SB-GA8-2008-41

Issue 2

Service Bulletin

Alternate Airbox Upgrade.

Figure 1

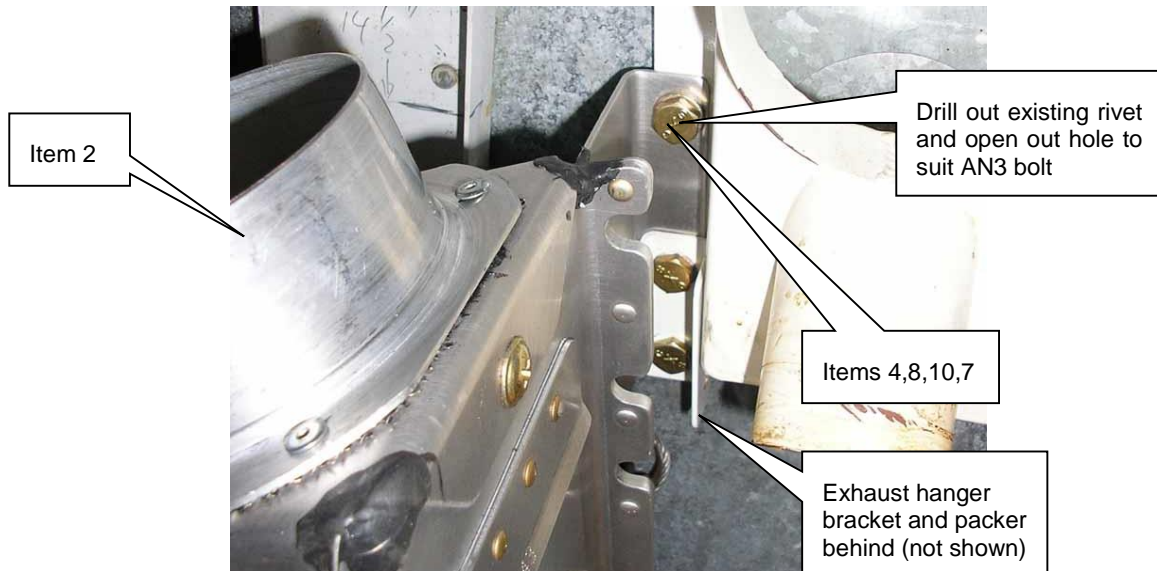
8. Drill out the 5/32" (3.97mm) rivet, directly above where the exhaust hanger bracket was (see Figure 1) and open out to suit AN3 bolt.
9. Place the new alternate airbox assembly over cabin heat valve assembly flange. Centrally align the 3 slotted holes. Refer to Figure 1.
10. While in place, mark out 2 holes in the side of the firewall channel and drill to suit AN3 bolt. Refer to Figure 2.
11. Remove the air intake plenum drain hose (3 sections and Tee piece), and replace with item 14 (one length of MIL-H-6000 ¼ hose 18.5 inches long).
12. Attach the new alternate airbox assembly with retained exhaust hanger bracket, and spacer, using AN hardware supplied in kit (see Figure 1). Fit three AN970-3 washers and three MS21042-3 10-32 reduced hex nuts on the inside of the firewall.

Figure 3

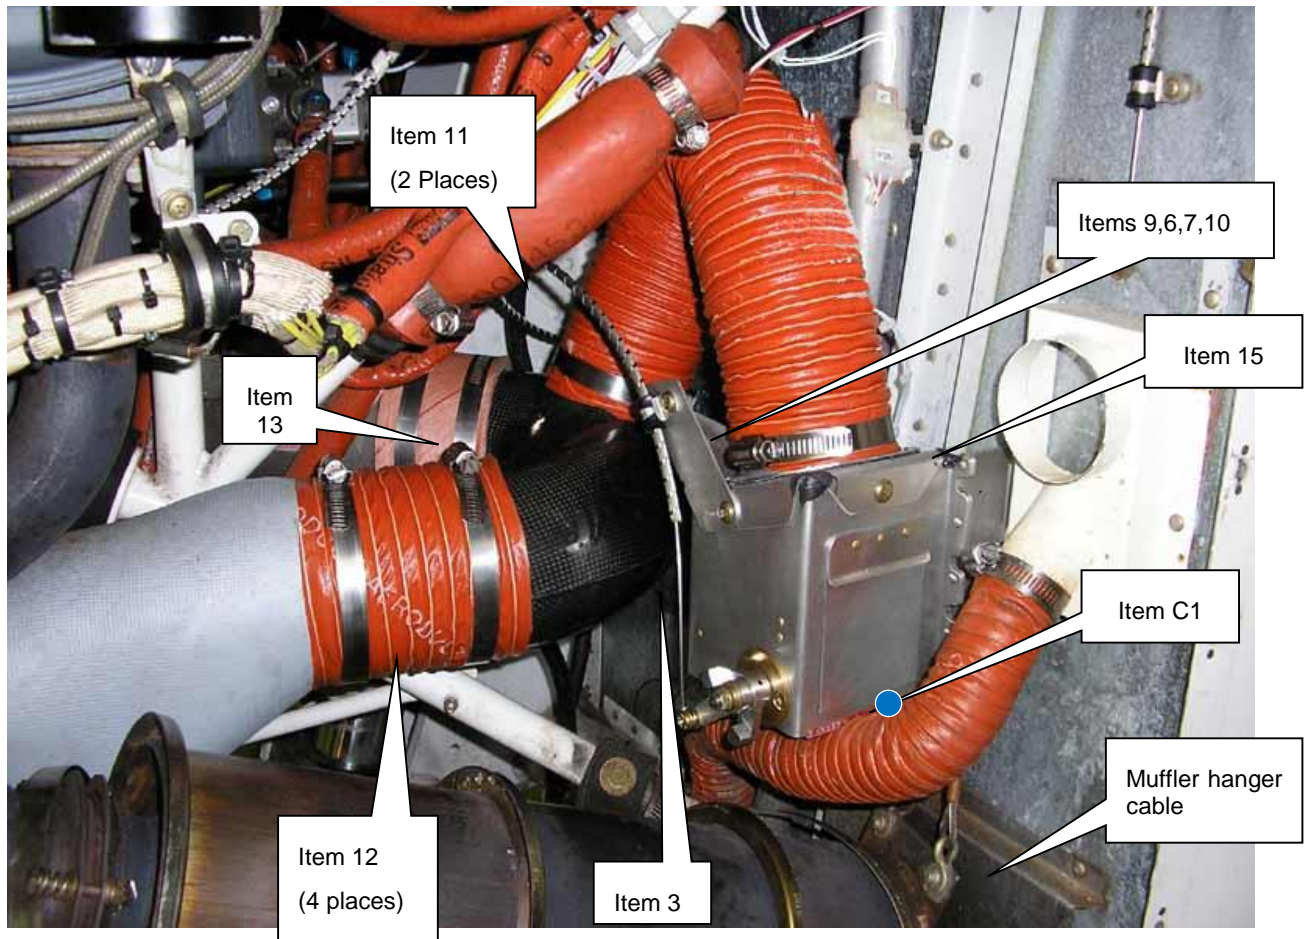
13. Fit the new airbox trunk to the injector with hose, P/N LW-15569 (the cut out in hose LW-15569 goes over the injector inlet). Fit the other end of trunk to the air filter assembly with scat 16 hose and hose clamps. Refer to Figure 3.

16. Apply a small amount of silicone (Item C1) between the alternate airbox and scot hose, at the area identified by the blue circle in Figure 3, to eliminate potential wear due to vibration.

Figure 4

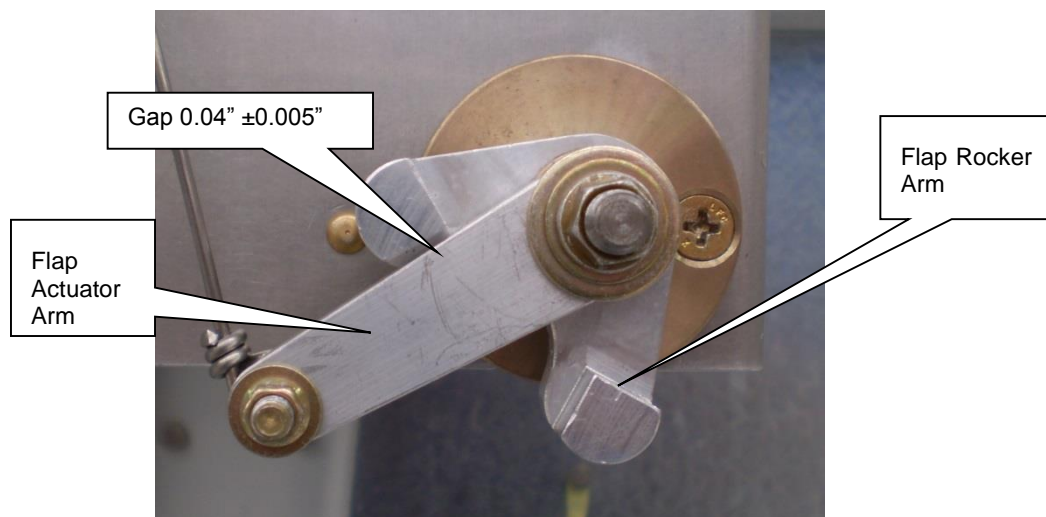
17. Re-attach the muffler hanger cable assembly.
18. Install alternate air cable (Item 1). Push the alternate air knob in fully. Rotate the Flap Rocker Arm fully anti-clockwise when viewed looking at the airbox in the aft direction. The Flap Actuator Arm is to be set $0.040'' \pm 0.005''$ from the upper stop of the Flap Rocker Arm as shown in Figure 4. Adjustments can be made by loosening the Cable Clamp and sliding the cable out through the Clamp. Secure the cable with the Cable Clamp following any adjustment. Cycle the alternate air control from closed to open several times to ensure correct operation.

Figure 5: Modified configuration. Additional cable ties are not shown.

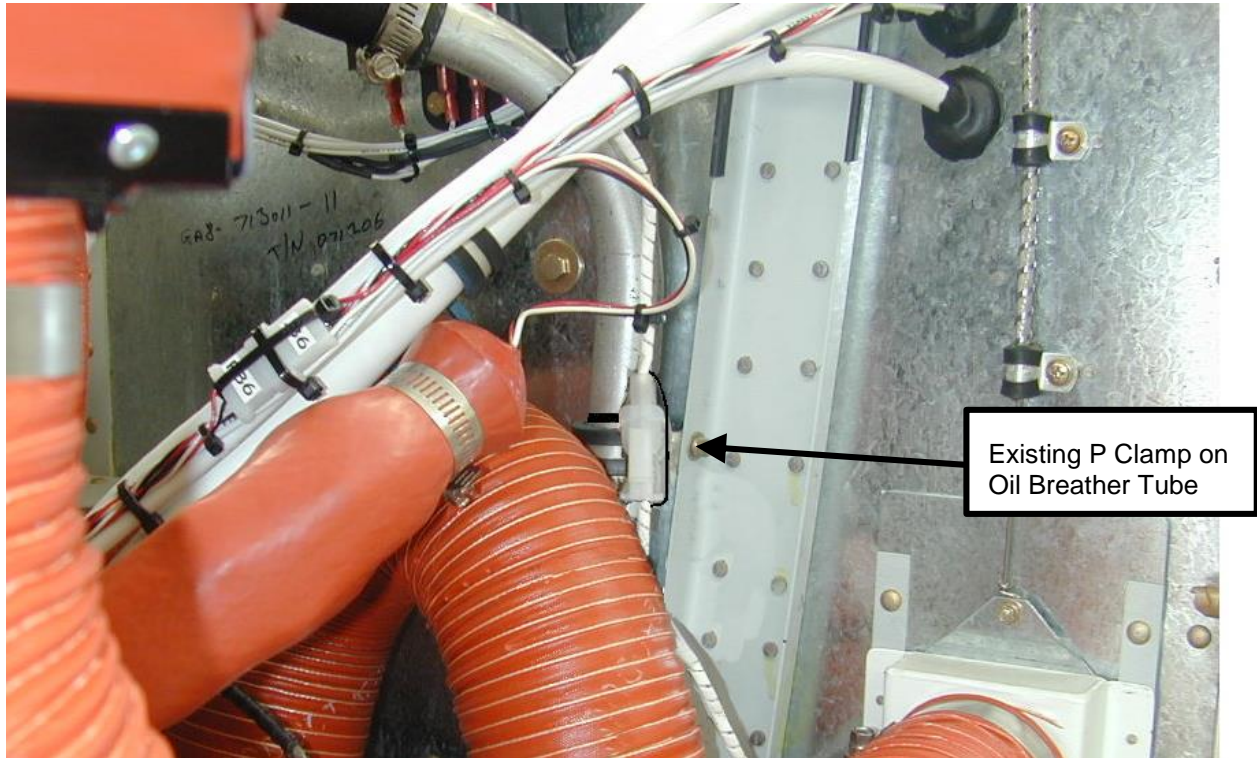
Issue 2: Loom Connector relocated to improve durability of associated loom Ref GAE11#2596

19. Plug in and secure the alternate air warning connectors (P26/J26) per Figure 5 and Figure 6. Confirm that the alternate air indicator illuminates with activation of the by-pass door. This can be achieved by opening and closing (pushing and pulling) the Alternate Air Control Cable to initialise the sensor circuit.
20. Reinstall any panels, cowls, etc, removed to gain access in accordance with the GA8 Service Manual.
